**APPLICATION FOR  
URBAN DESIGN COMMISSION  
REVIEW AND APPROVAL**

PROJECT ADDRESS: 25 W. MAIN ST., MADISON, WI 53703

# PROPOSED CHANGES TO THE REDEVELOPMENT OF ANCHOR BANK

submitted as a minor alteration to previously  
approved conditional use by the City of  
Madison and the Urban Design Commission

## II. THE EAST END OF THE BUILDING ALONG MAIN STREET WILL HAVE AN UPDATED FAÇADE

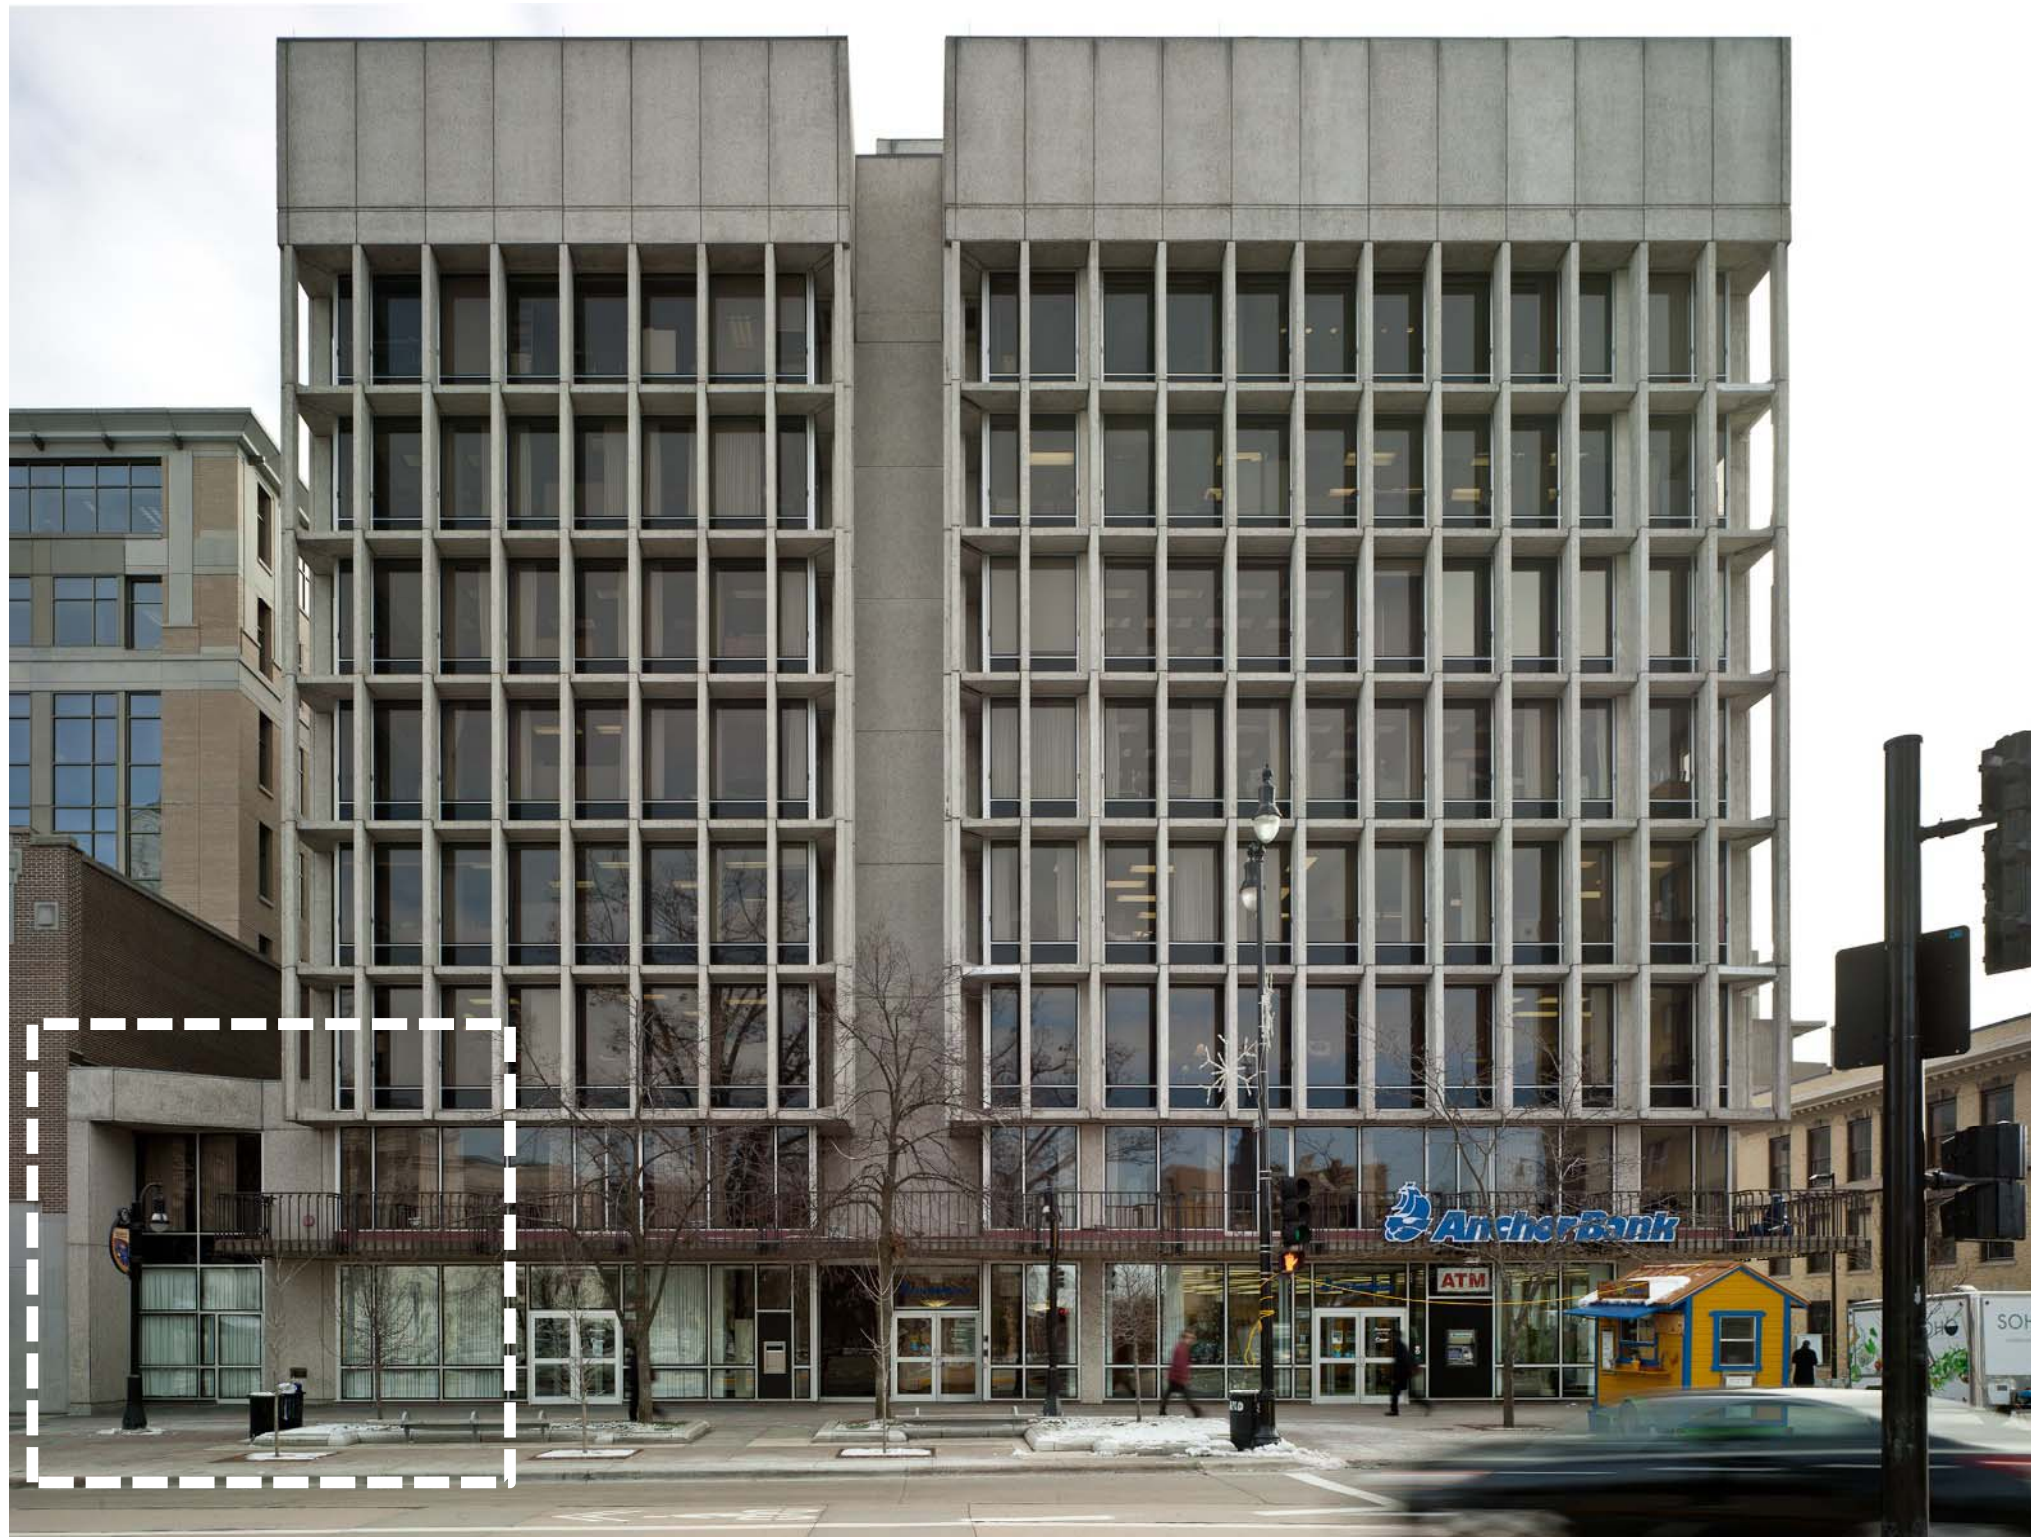
In the plans previously approved by the City, the geometry and façade of the east end of the building at Main Street was to be maintained. Anchor Bank has committed to relocate its retail branch to the east side of the ground floor so that the west side of the building adjacent to Carroll Street can be converted to restaurant use, which will add life and vitality to the ground floor of the building. Anchor wants to create a more transparent facade that will be a dynamic entrance to the new retail branch bank. A transparent glass railing will be installed above the new glass storefront to create more visibility for and from the existing third floor roof terrace. The new entrance is consistent with the sophisticated design of the building, instead of being an old artifact of the original building.

# III. THE SIZE OF THE ADDITION TO THE BUILDING HAS BEEN EXPANDED TO CREATE A MORE FUNCTIONAL FLOORPLATE THAT CAN ATTRACT NEW OFFICE TENANTS

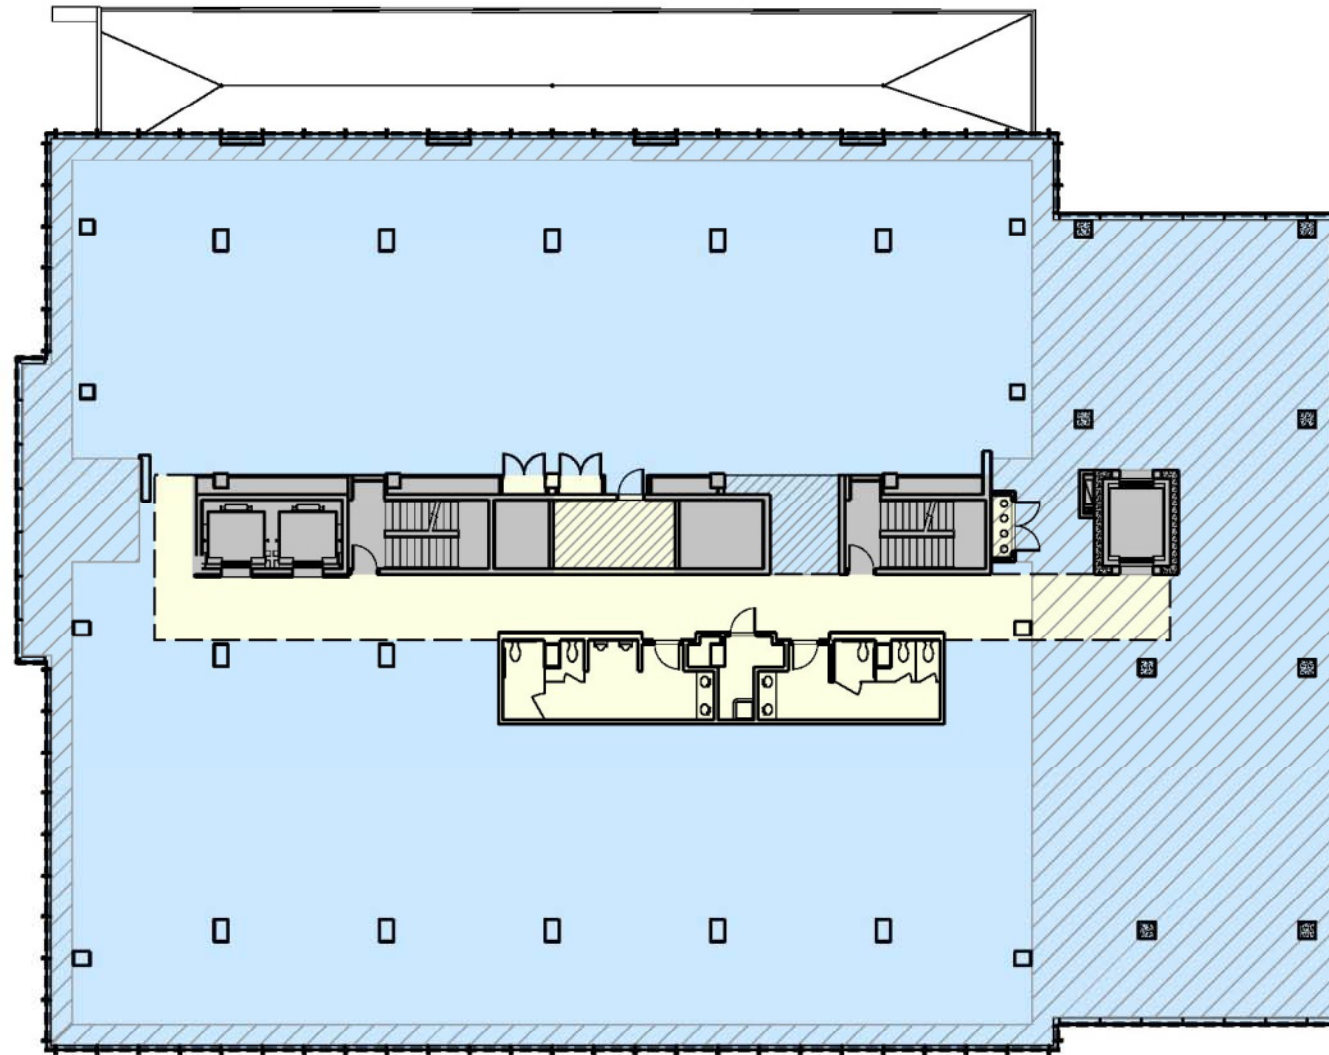
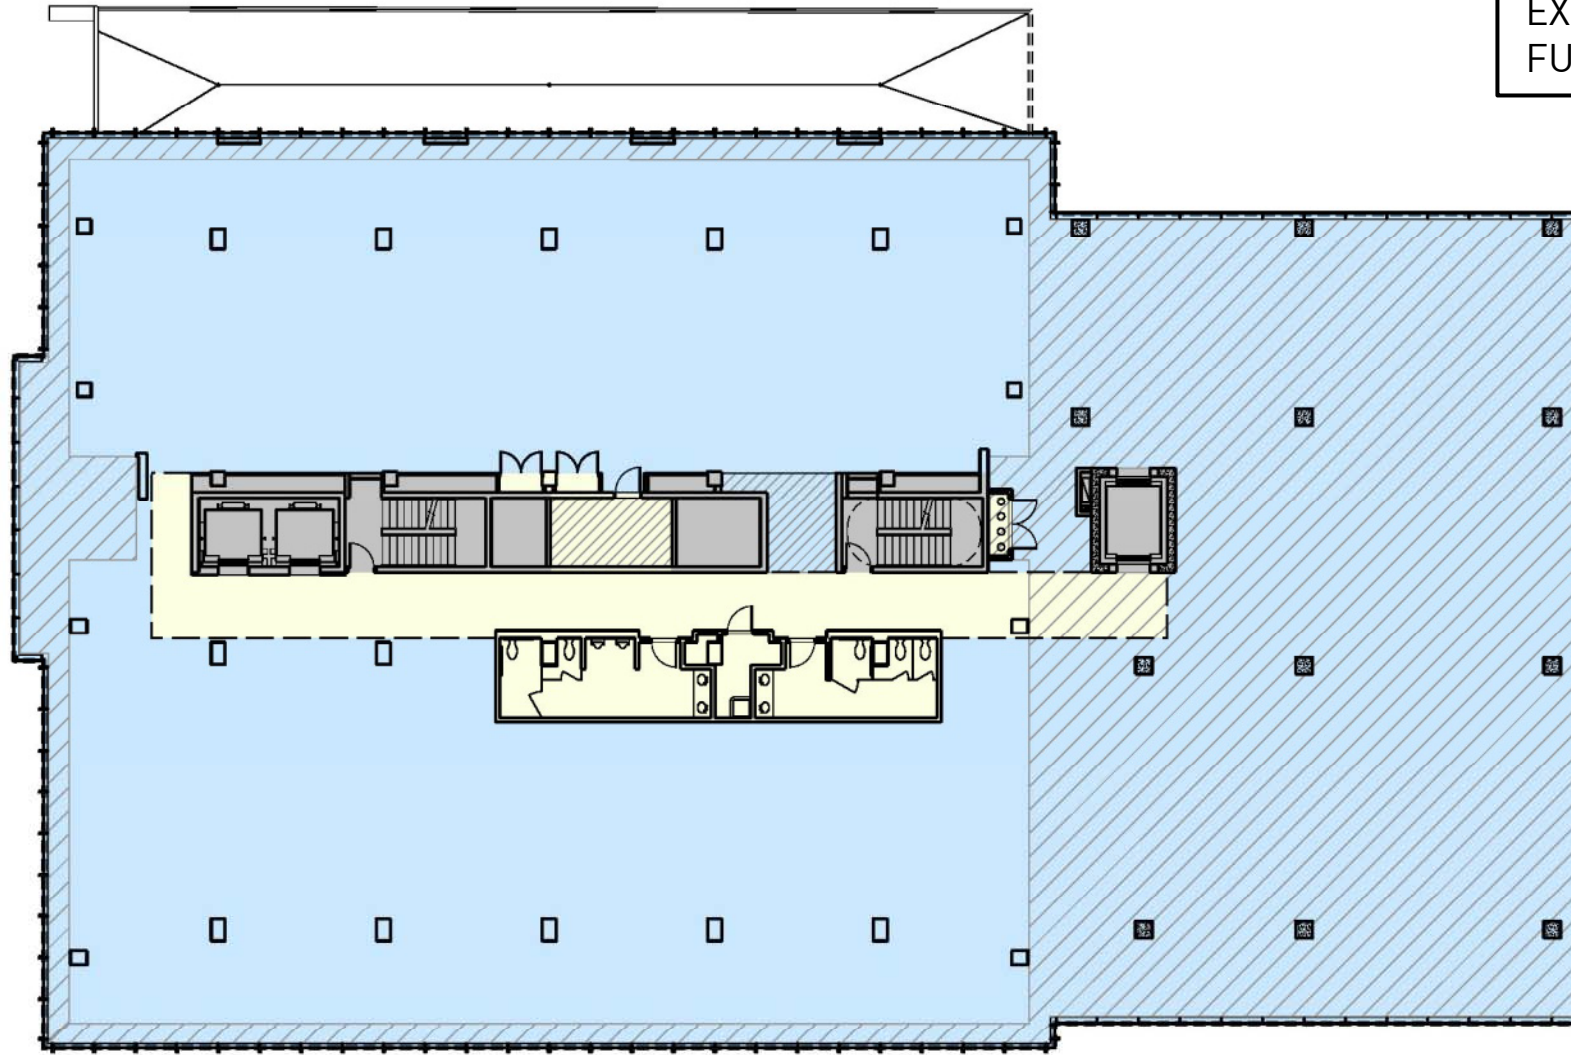
Anchor Bank has made a decision to lease approximately 30,000 square feet of space in the renovated building and will relocate back of house functions to less expensive space. This decision makes it critical to create a floor plate that can attract other new tenants. The building addition has been pushed one structural bay to the south to create floor plates that are around 19,000 rsf. With the larger floor plates, the total rentable area in the building will increase by 26,346 rsf to contain a total of **191,577 rsf**. City staff had encouraged additional density above the current surface parking lot when the original building concepts were presented and approved.

The larger floor plates we are proposing offer far more functional area on the southern end of the floor plate and give the building a strong competitive advantage in the downtown market. THE newest office buildings on the Capitol Square provide a floor plate of 15,000 rsf. Because of the larger floor plates, ULI is in serious discussions with a prospective tenant not presently located on the Capitol Square who is considering relocating into Anchor Bank. The prospective tenant needs 60,000 square feet of office space to accommodate its space needs and could fit onto three adjacent floors.

The larger addition maintains the architectural character and detailing of the new curtain wall that the City had previously approved.

SPACE BETWEEN CORE AND SOUTH WALL IS LIMITED.

EXTENDING THE FLOOR PLATE ADDS FUNCTIONAL USABLE FLOOR AREA.
